GAFFNEY BOARD OF PUBLIC WORKS

I-85 SEWER EXTENSION  
CONTRACT 1C – COLLECTIONS

ADDENDUM NO. 6

January 10, 2024

C-06-103A

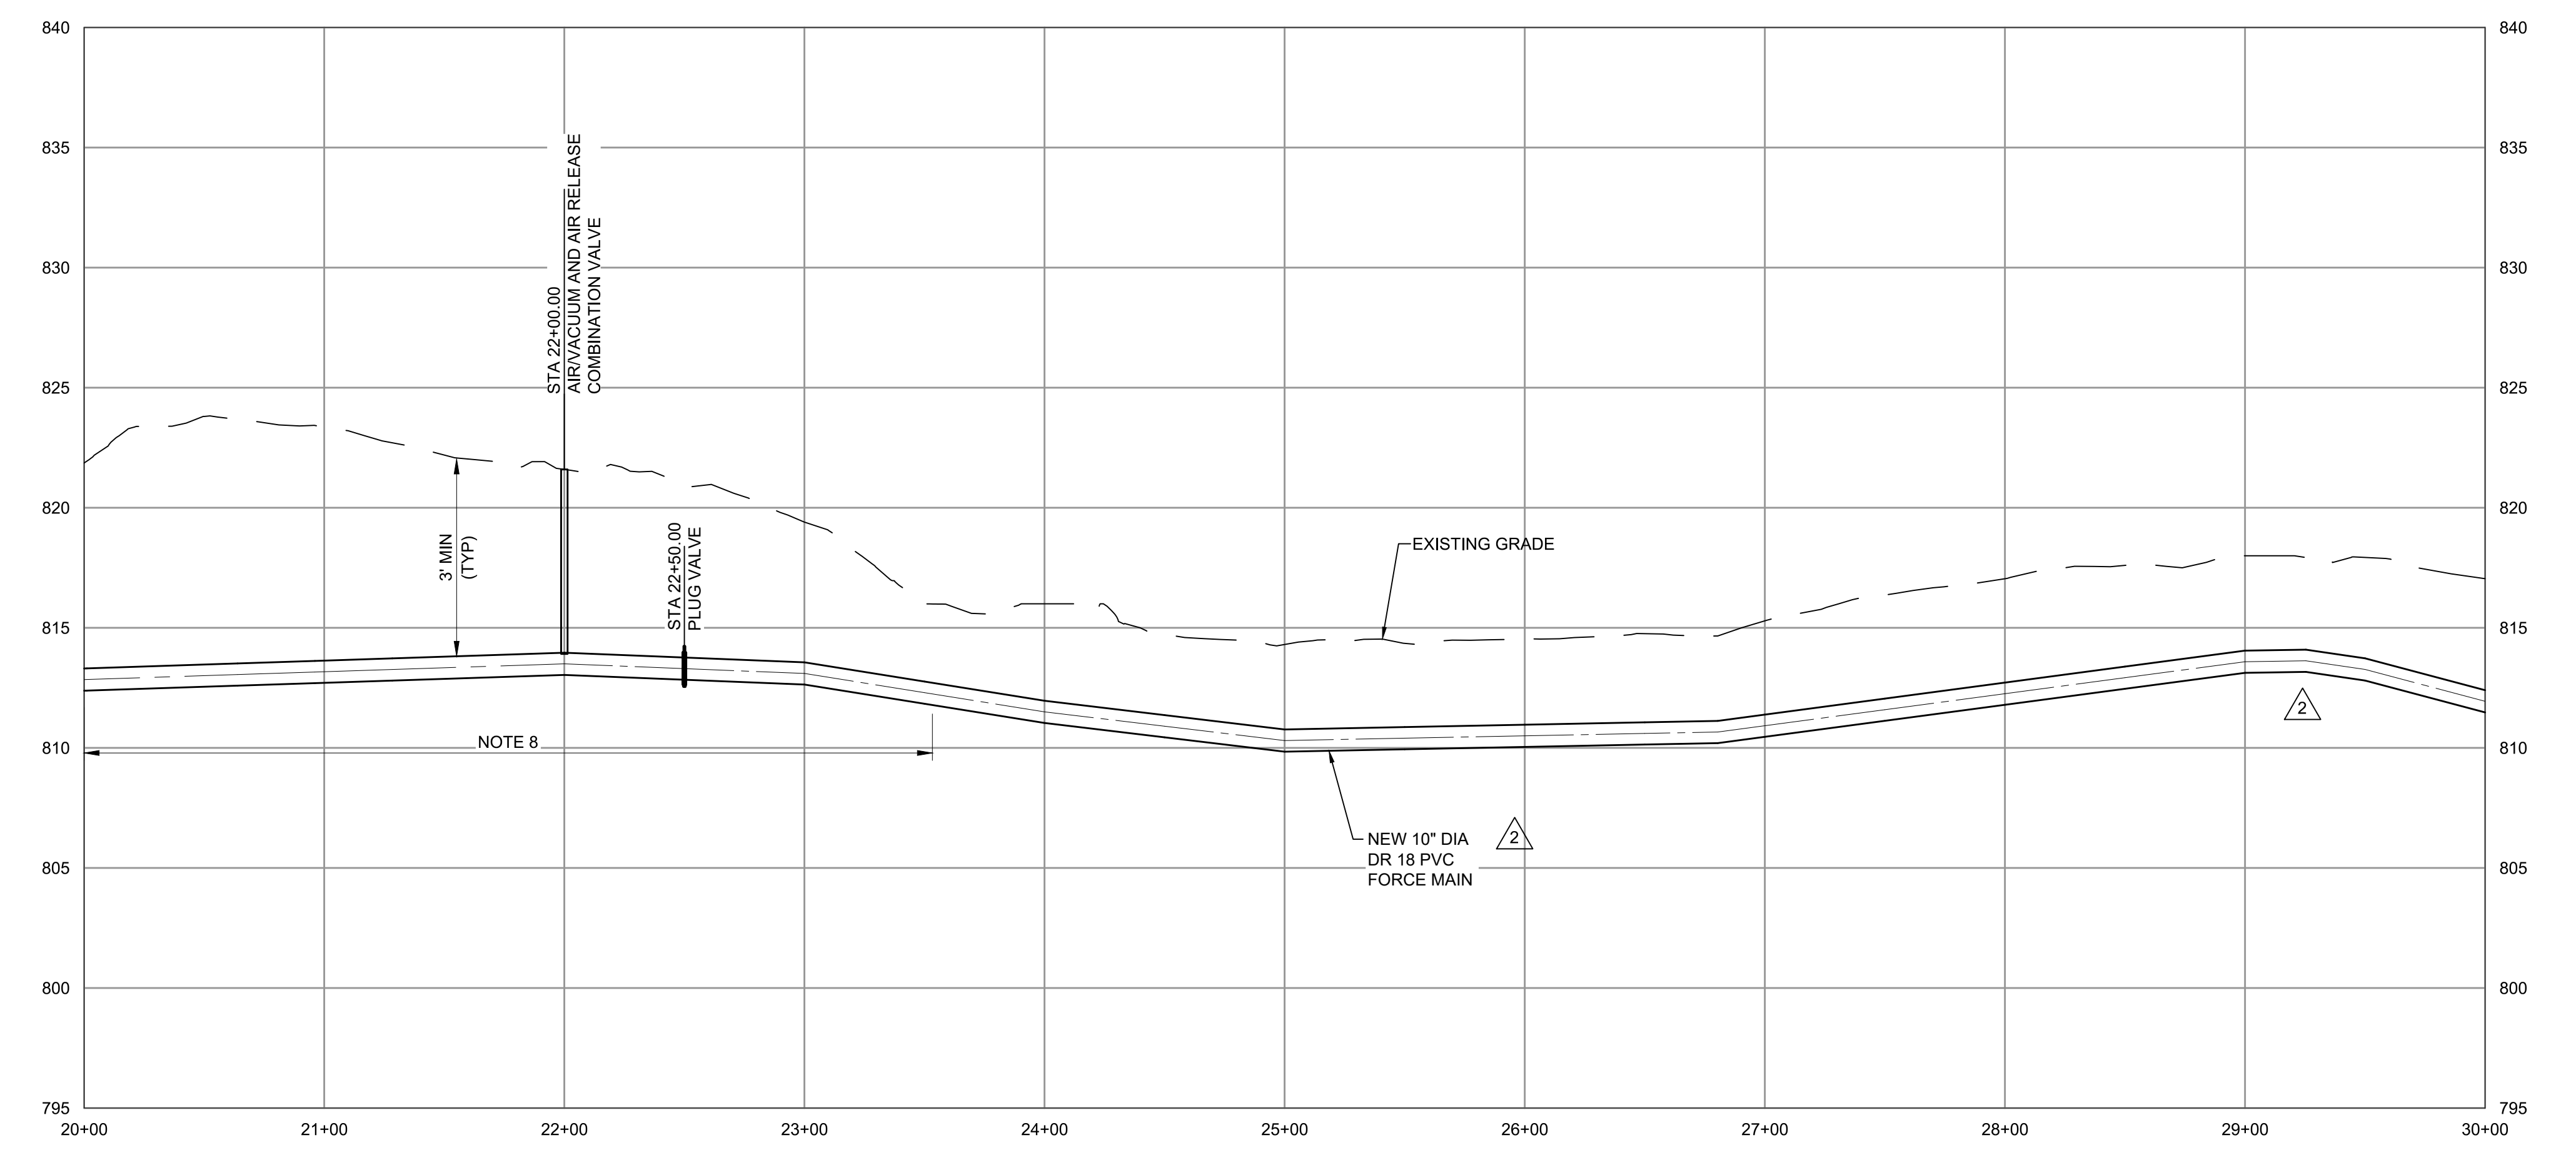
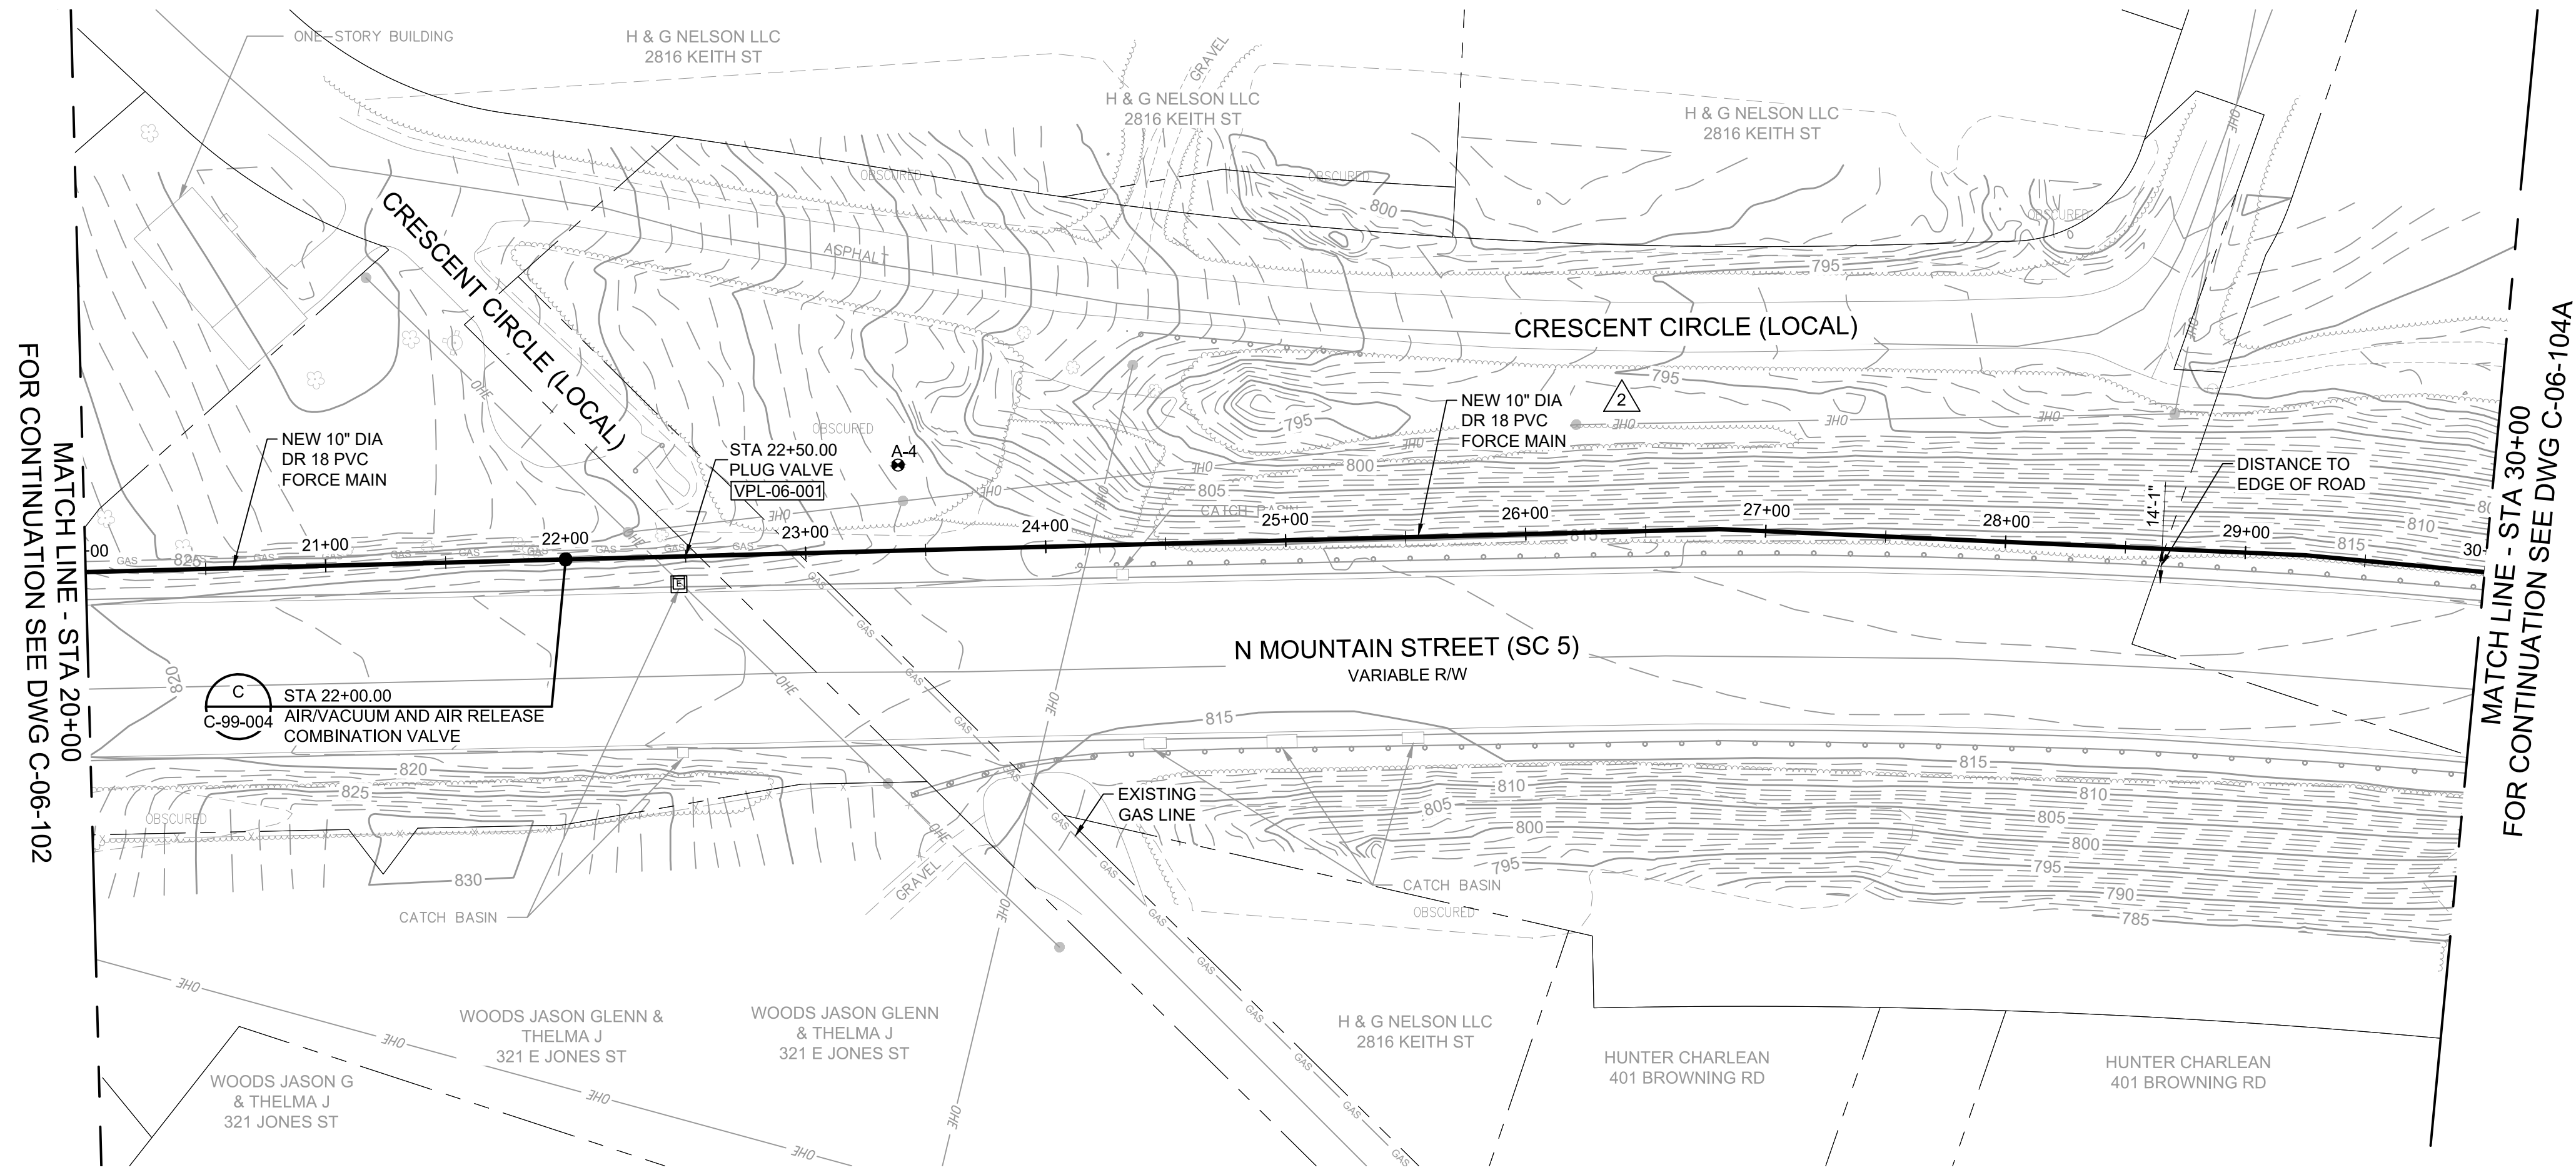
- i. Insert the attached new sheets C-06-103A and C-06-104A for Segment 6 Alternative 1 and the new sheet C-08-102A for Segment 8 Alternative 2 after sheet C-16-109.
- ii. Insert the attached new sheets S-00-001, S-01-101A, and S-01-102A for the Alternatives after sheet C-99-006.
